AN ORDINANCE approving a master plan for Virginia Mason Medical Center.

EXHIBIT A: FINDINGS CONCLUSIONS AND DECISION OF THE CITY COUNCIL

**VIRGINIA MASON MEDICAL CENTER
PROPOSED REVISION TO MAJOR INSTITUTION MASTER PLAN**

MIMP Application No. 8701306

Revised Figure 10

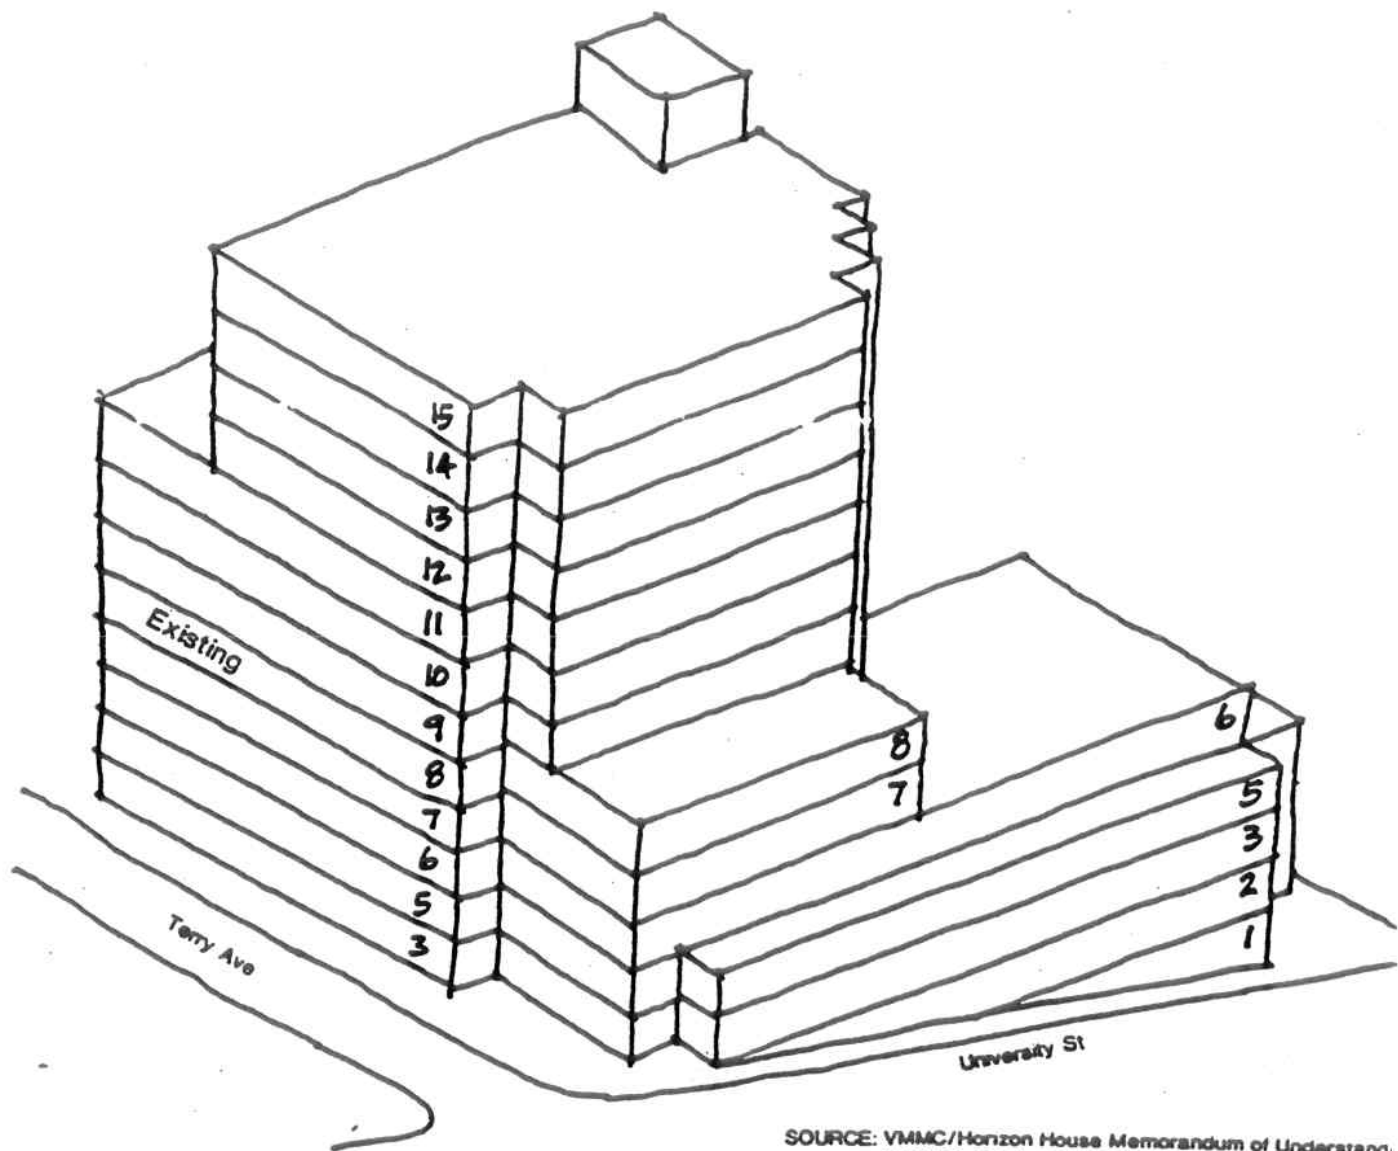
1. Figure 10 at p. 30 (Proposed Development) of the Final Major Institution Master Plan will be amended to read as shown in Revised Figure 10 (Proposed Development/Campus Plan). Revised Figure 10, along with Exhibit A and Exhibit B to Revised Figure 10, are attached to this proposed revision;
2. The following text will be appended to Section IV(C)(3)(b) at p. 28 of the Final Major Institution Master Plan:

North Campus Addition Modified Proposal -
View from Northeast
Virginia Mason Medical Center Major Institution Master Plan

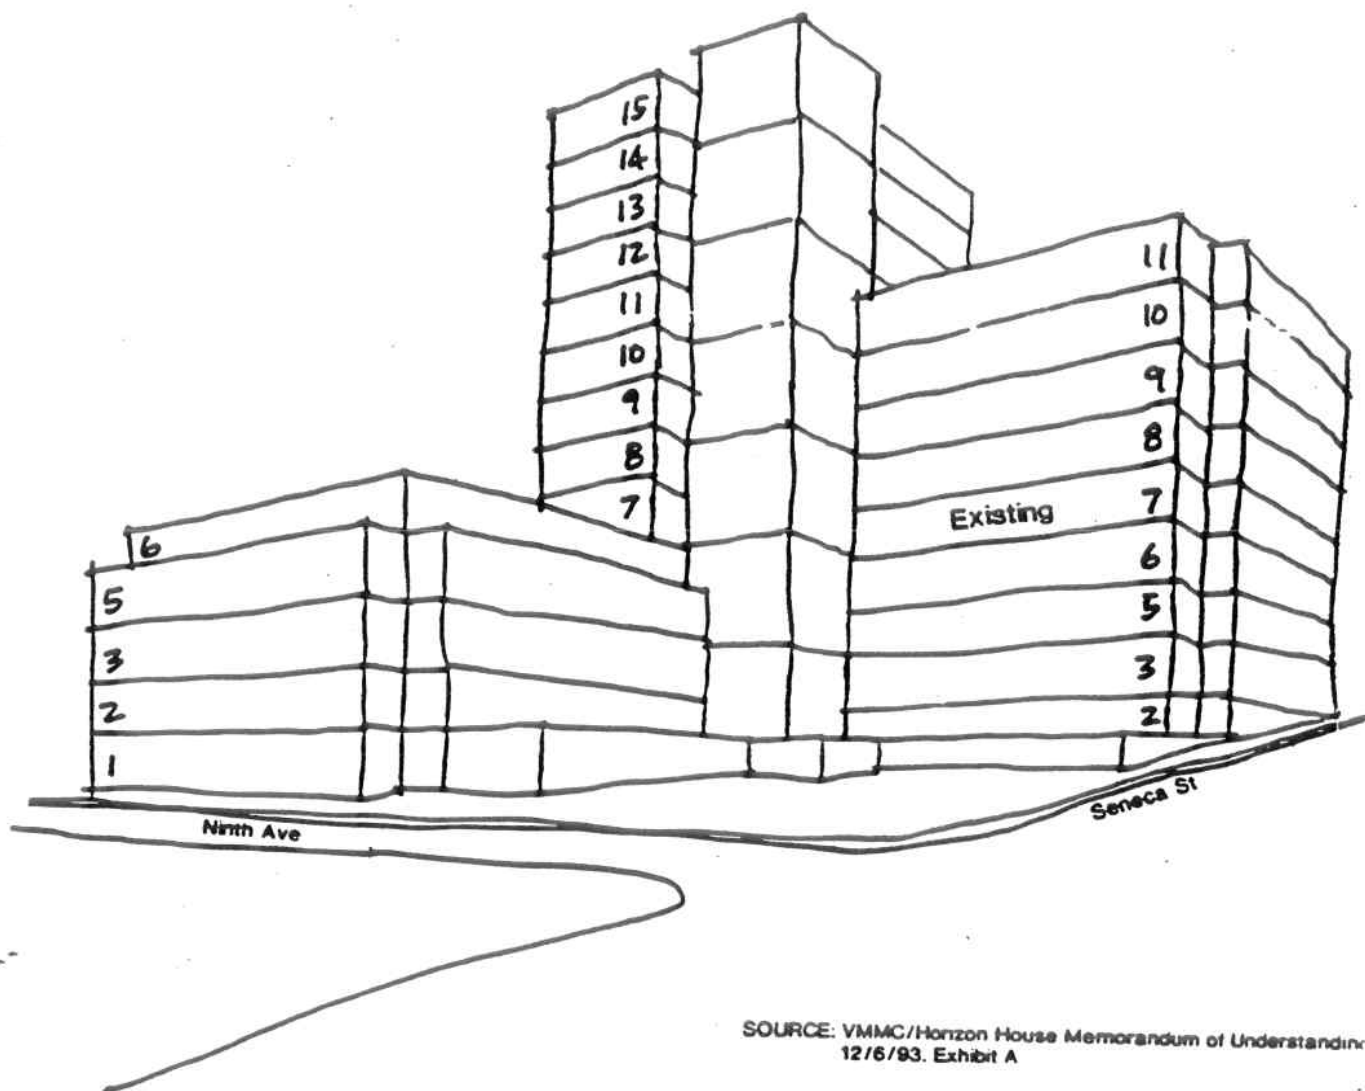
The proposed footprint and envelope of the North Campus Addition are shown in Exhibit A to Revised Figure 10. The design will be integrated with the existing North Pavilion to create a visual unity of design. As shown on Exhibit A, no windows will be located on the north facades of the North Campus Addition corners. Windows on the north facade will be angulated to mitigate visual intrusion to Horizon House. Virginia Mason will propose to locate the entrance/exit to the North Campus Addition parking garage on streets other than University Street, although final authority to approve ingress and egress onto public streets will rest with the City of Seattle.

Mixed Use Building Open Space Comparison
 Virginia Mason Medical Center Major Institution Master Plan

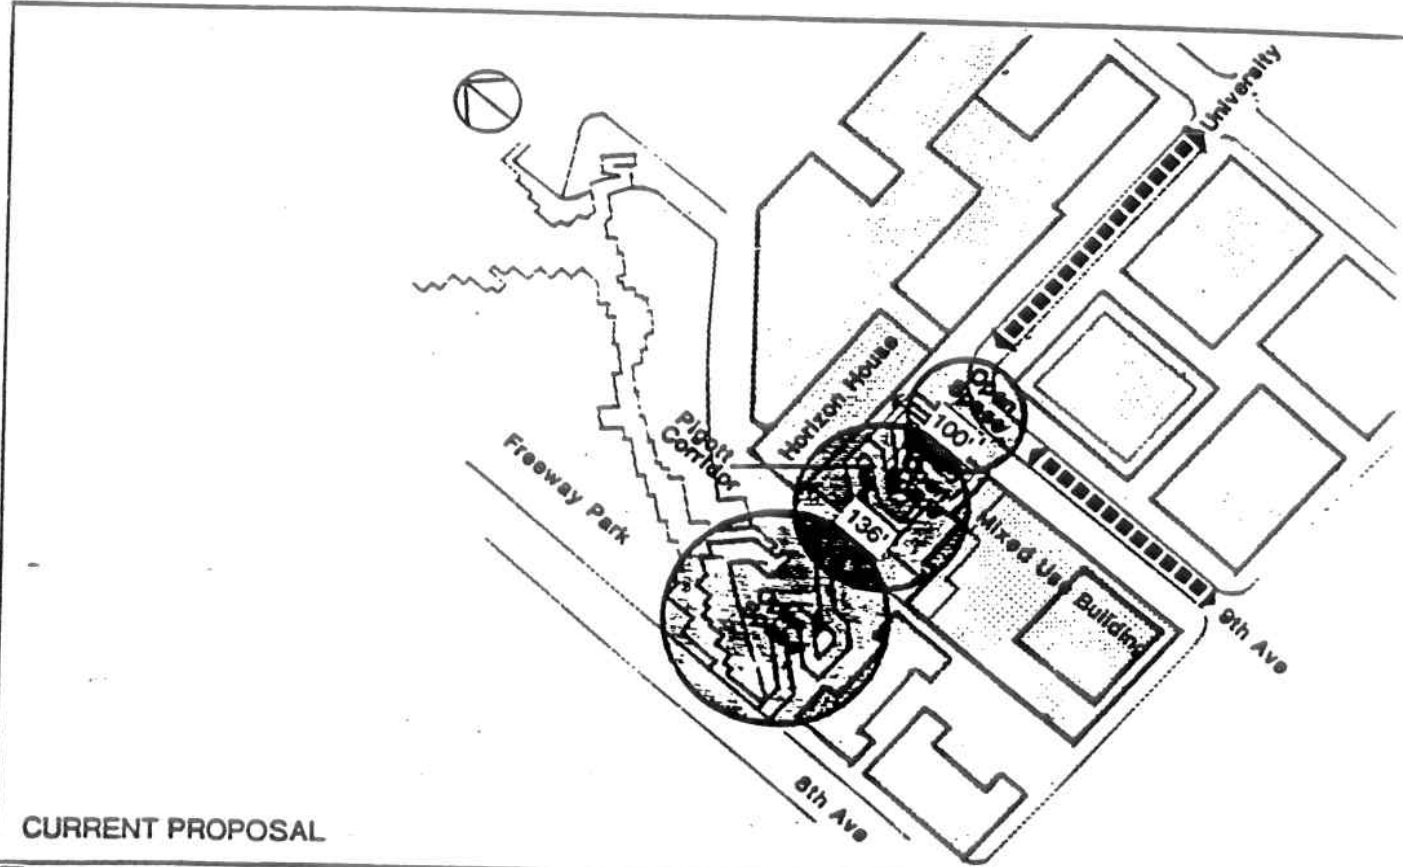
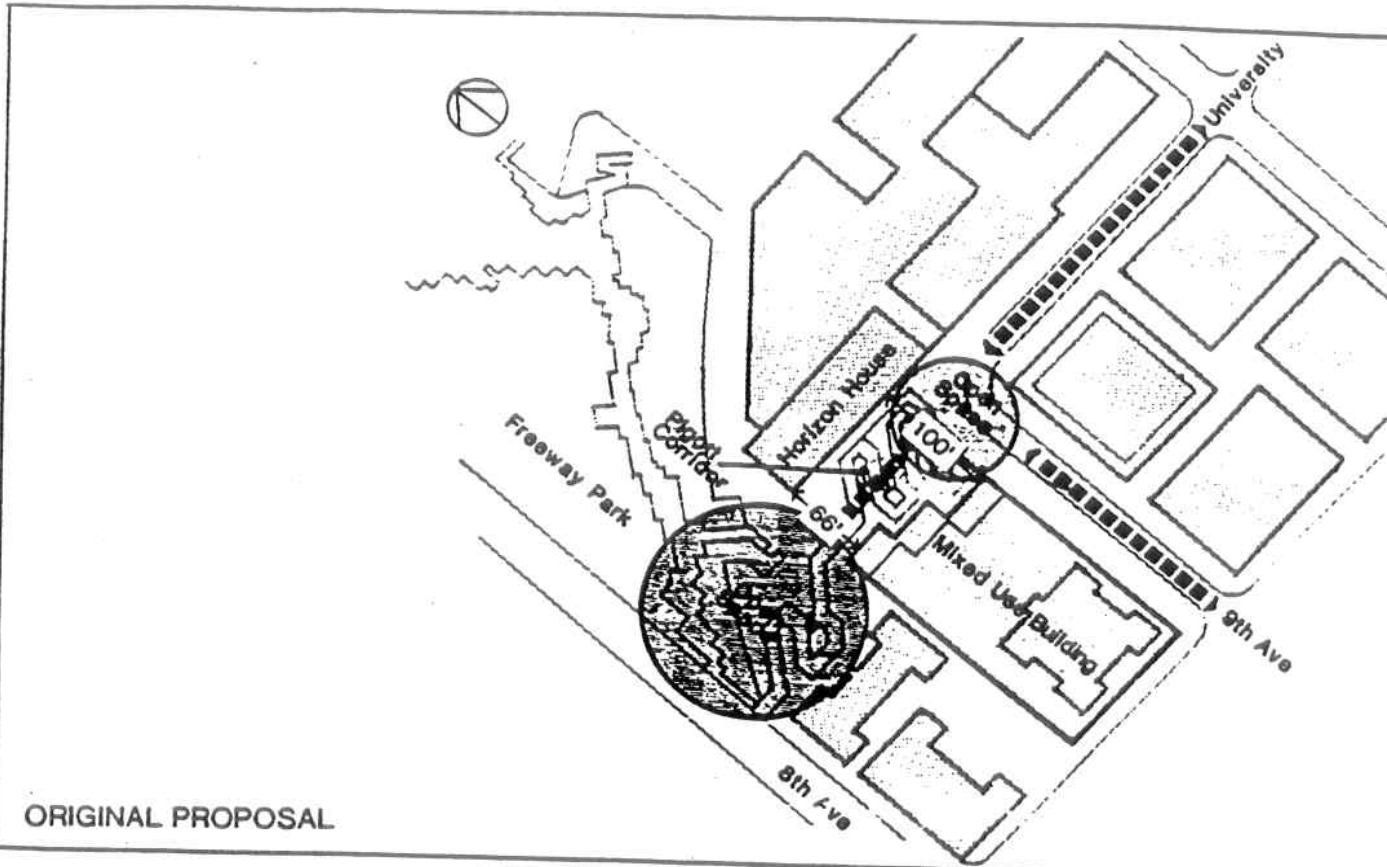
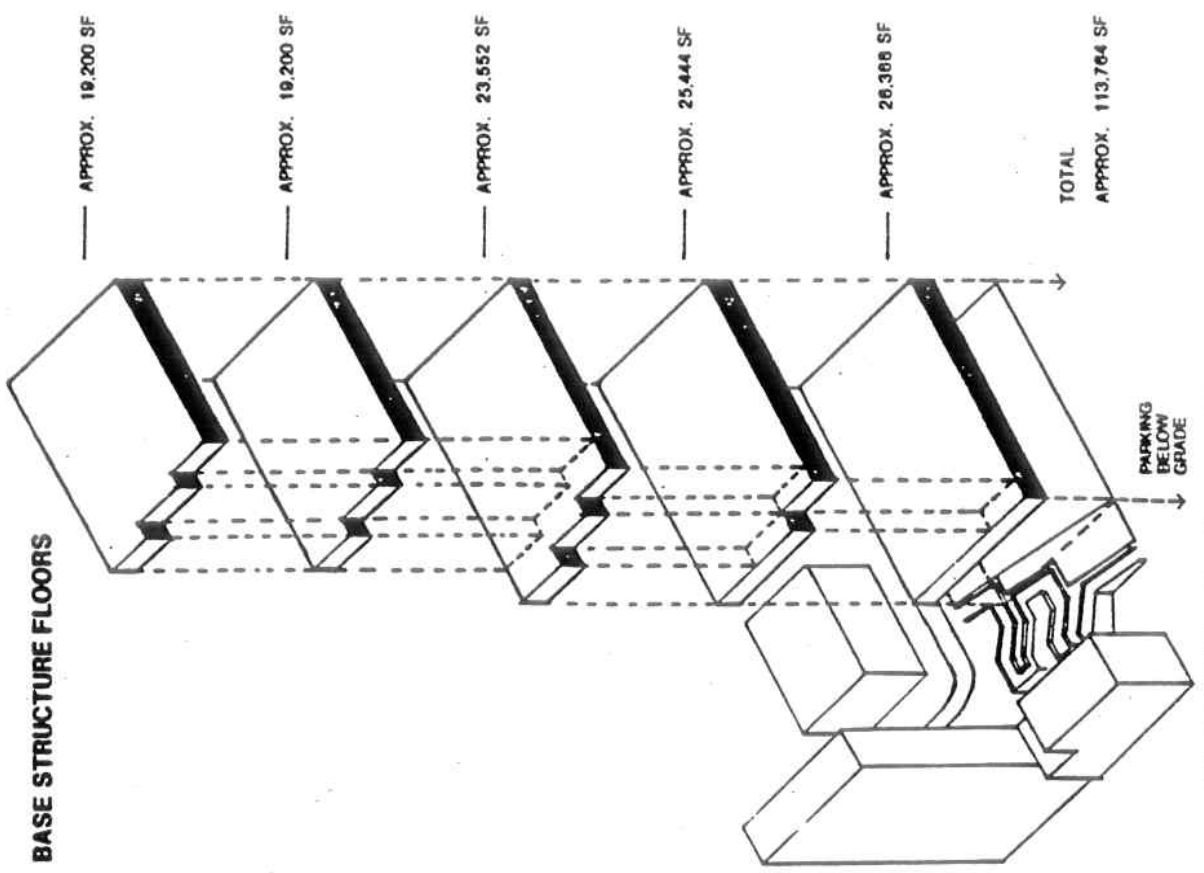
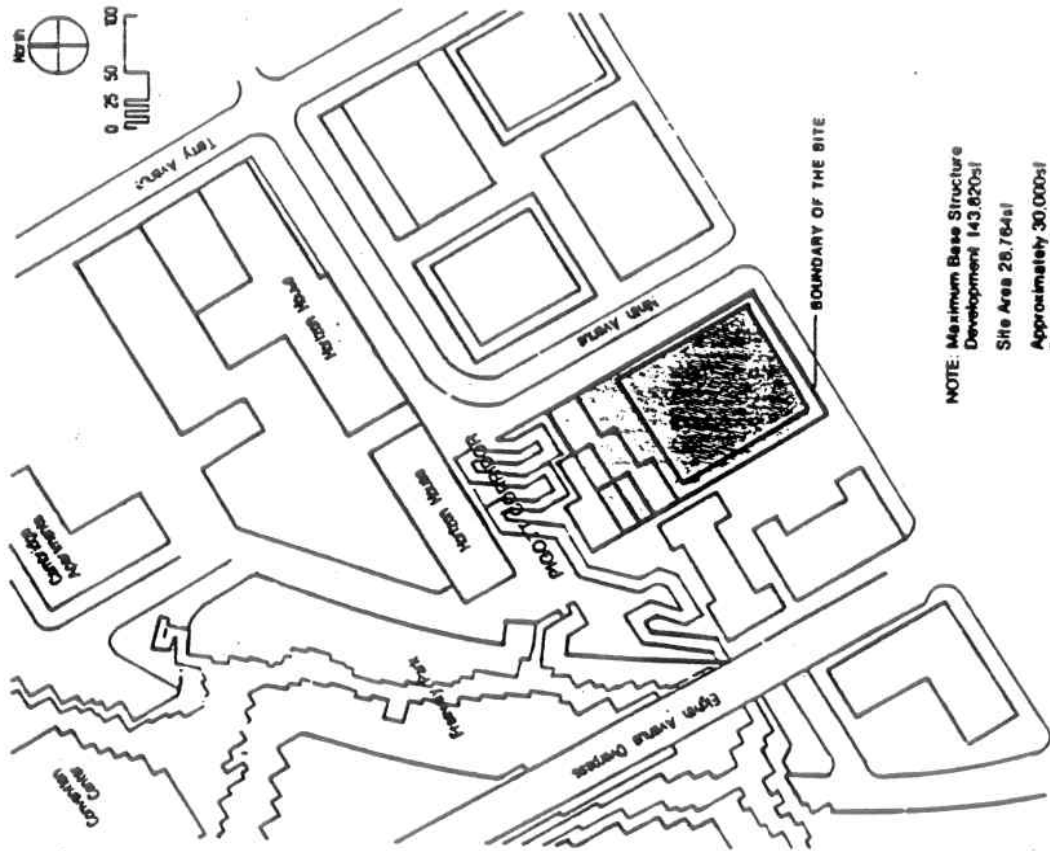
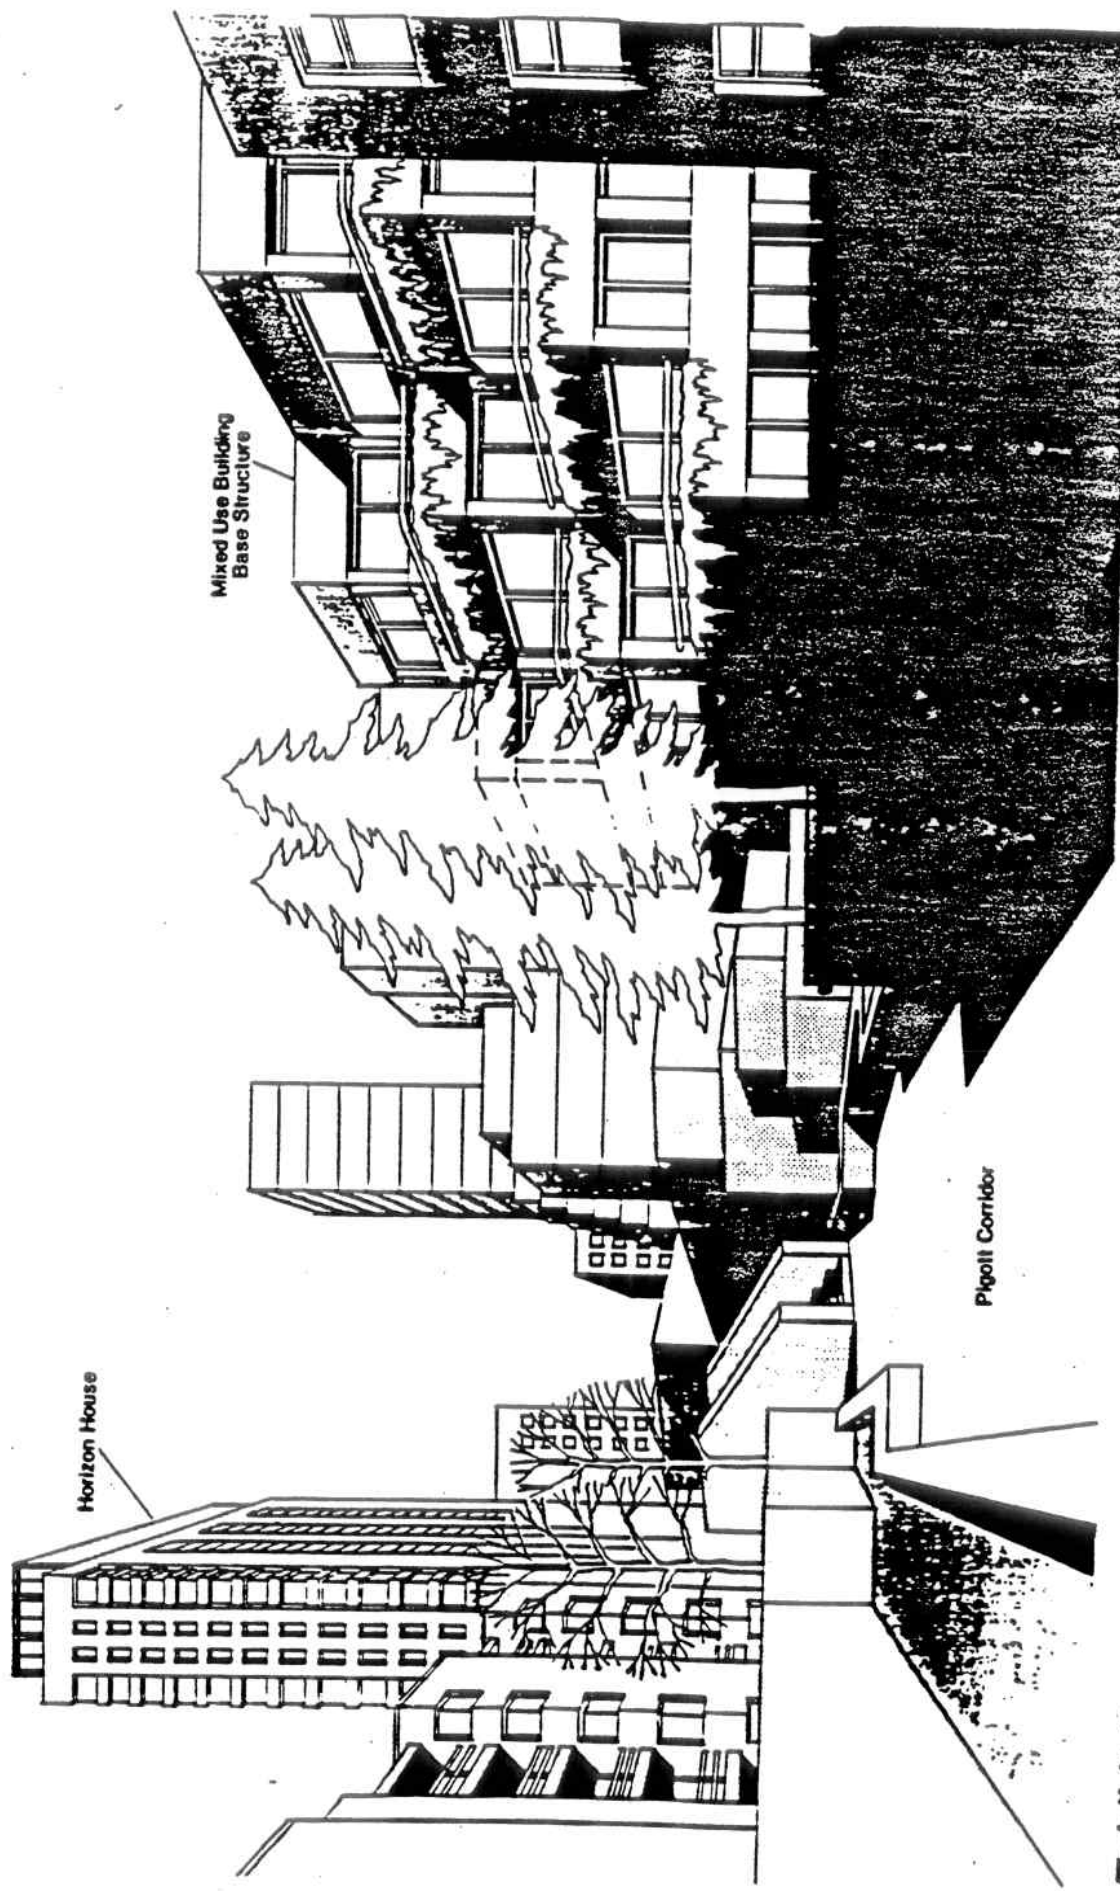
The setbacks and terracing of the Mixed Use Building are shown in Exhibit B to Revised Figure 10. Virginia Mason will seek to locate the entrance/exit to the Mixed Use Building parking garage on Seneca Street, subject to City of Seattle approval.
